**Verification report for GS4GG Programme of Activity
(Gold Standard for the Global Goals)**

Title of the GS4GG Project	GS1247: Improved Kitchen Regimes Multi-Country PoA GS1247 VPA 65 Zoba Debub Community Boreholes (GS5038) GS1247 VPA 66 Zoba Dzebub Community Boreholes (GS5039) GS1247 VPA 67 Zoba Debub Community Boreholes (GS5040) GS1247 VPA 68 Zoba Debub Community Boreholes (GS5041) GS1247 VPA 69 Zoba Debub Community Boreholes (GS5042) GS1247 VPA 70 Zoba Debub Community Boreholes (GS5043) GS1247 VPA 119 Zoba Debub Community Boreholes (GS5825) GS1247 VPA 120 Zoba Debub Community Boreholes (GS5826) GS1247 VPA 121 Zoba Debub Community Boreholes (GS5827) GS1247 VPA 176 Zoba Debub Community Boreholes (GS7330) GS1247 VPA 177 Zoba Debub Community Boreholes (GS7331) GS1247 VPA 178 Zoba Debub Community Boreholes (GS7332) GS1247 VPA 179 Zoba Debub Community Boreholes (GS7333) GS1247 VPA 180 Zoba Debub Community Boreholes (GS7334) GS1247 VPA 181 Zoba Debub Community Boreholes (GS7335) GS1247 VPA 182 Zoba Debub Community Boreholes (GS7336)

Version number of the monitoring report to which this report applies	4.0 Dated: 31/07/2024
Coordinating/managing entity (CME)	CO2balance UK Ltd.

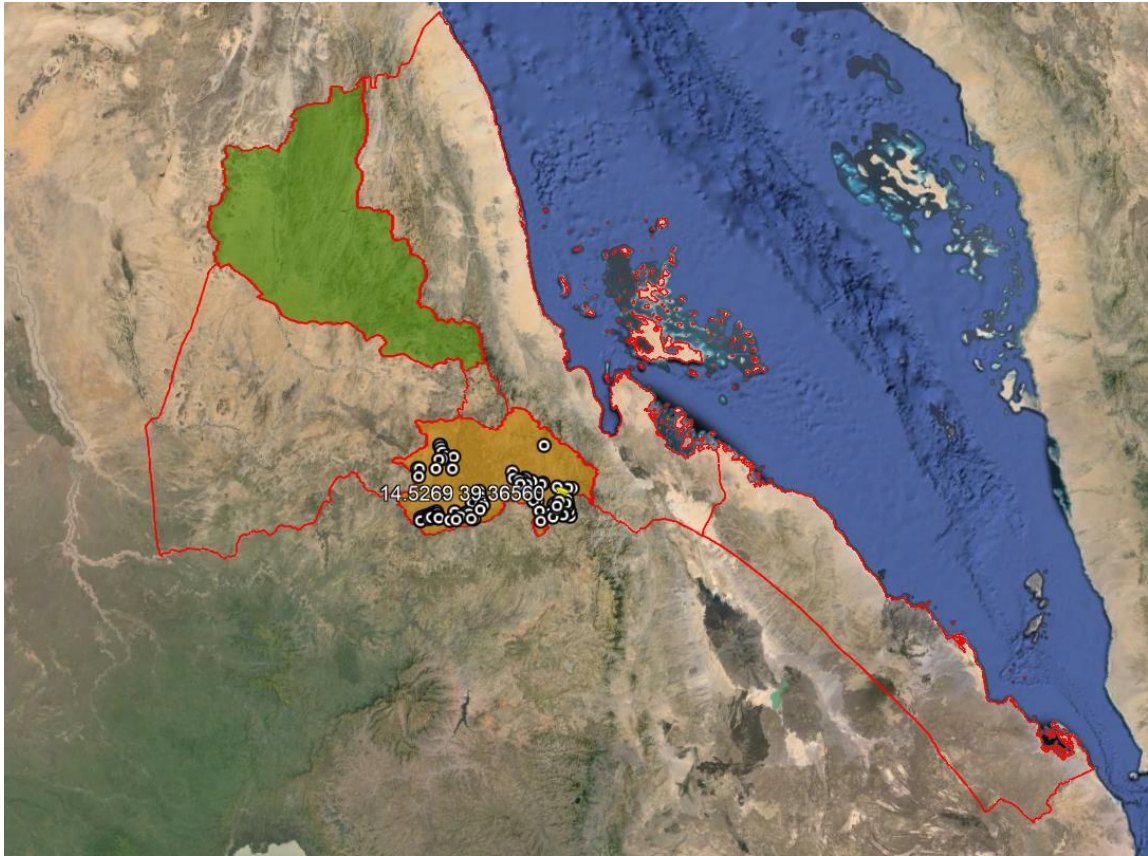
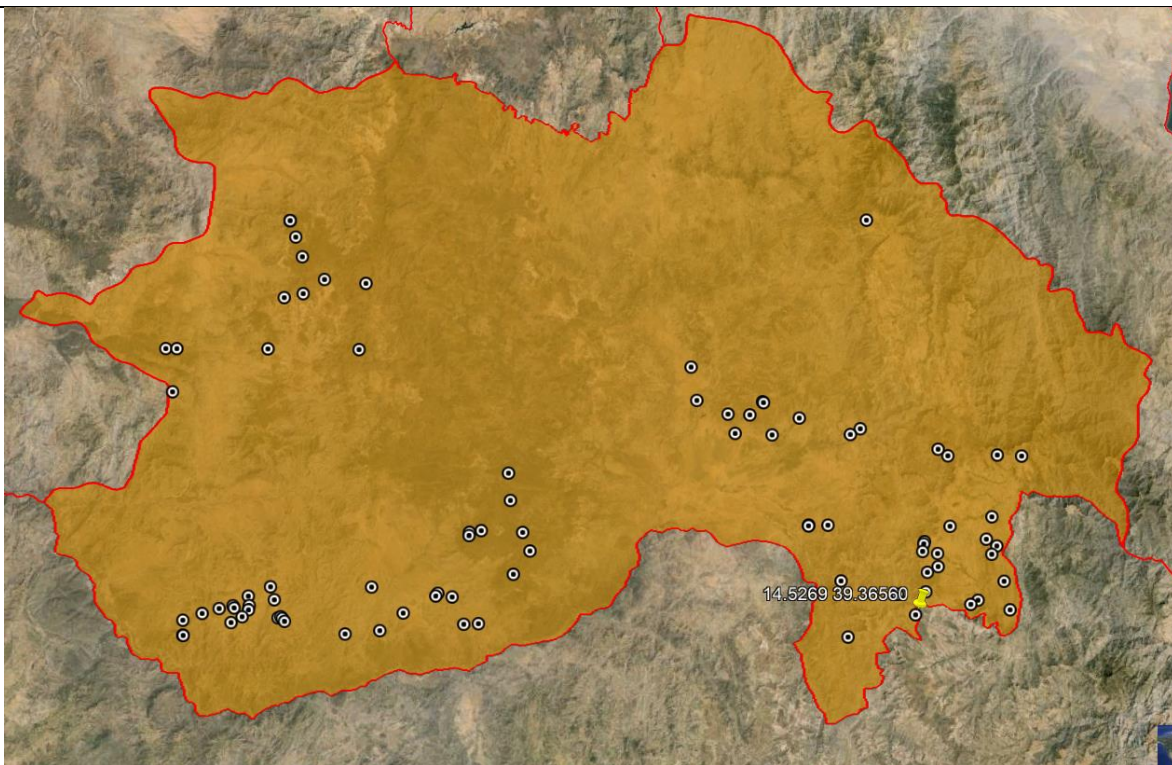
CL ID	02	Section no.	A	Date : 20/02/2024
Description of CL

Following observation under section A are as follows:

1. Under section A.1 & B.1 of the MR. PD has reported "In total 87 boreholes were rehabilitated as part of these project", PD to clarify and indicate the type of rehabilitation carried out for the boreholes or new boreholes were drilled.
2. The GPS coordinates reflected under the table of the section A.1 "VPA 70, GS ID: 5043, Borehole ID: ZD048, Village: Ambesetegheleba" is found to lie in the country Ethiopia. Screenshot has been given below for your reference. PD is requested to clarify.

PD has plotted the boreholes into Google Earth app (please refer to maps above that show Eritrea and, in Orange, the Debub Region): all BHs are within Debub Region in Eritrea, and specifically ZD048 (that is marked with the yellow hold) is as well the Eritrea borders. Thus, PP can confirm that all data points are within the project boundaries.

VVB assessment	Date: 17/04/2024
The GPS data points shared by the CME were reviewed with the information provided in the database. The assessment team checked through QGIS & google earth and found the documents and geo coordinates of the boreholes to be consistent with VPA-DD. As all the boreholes plotted lied inside the project boundary and the clarification provided by the CME was found to be acceptable. Hence, CL#02 is closed.

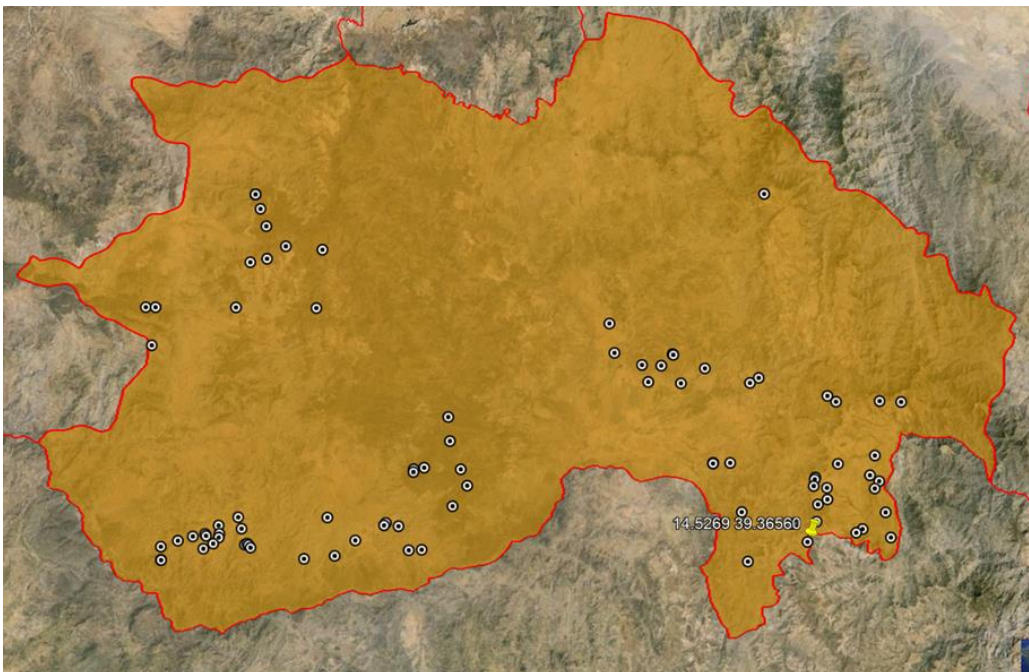
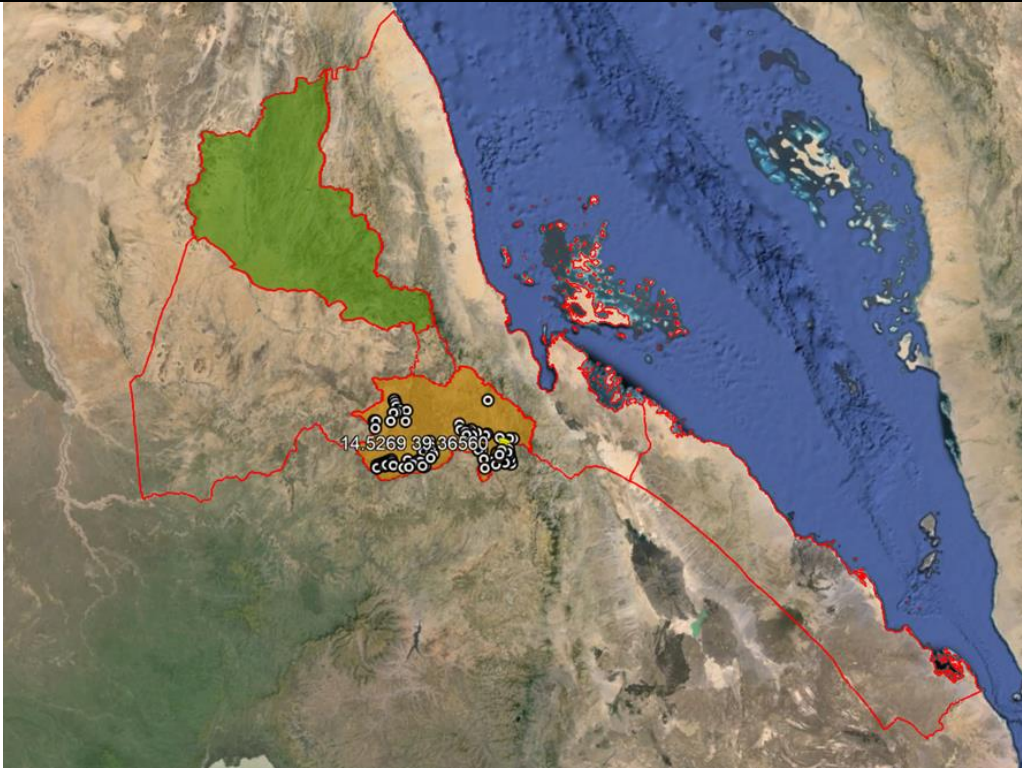
PP is requested to provide clarification as to how the GPS location was collected and how PP ensured the data QA/QC after the data collection. Considering that some of the GPS data points fall outside the project boundary due to poor satellite coverage or poor GPS signal, the PP is requested to clarify as to how the remaining data points are correctly geo-referenced or mapped so that those points can be verified. The finding CAR#01 is OPEN.

PD has plotted the boreholes into Google Earth app (please refer to maps above that show Eritrea and, in Orange, the Debub Region): all BHs are within Debub Region in Eritrea, and specifically ZD048 (that is marked with the yellow hold) is as well the Eritrea borders. Thus, PP can confirm that all data points are within the project boundaries.
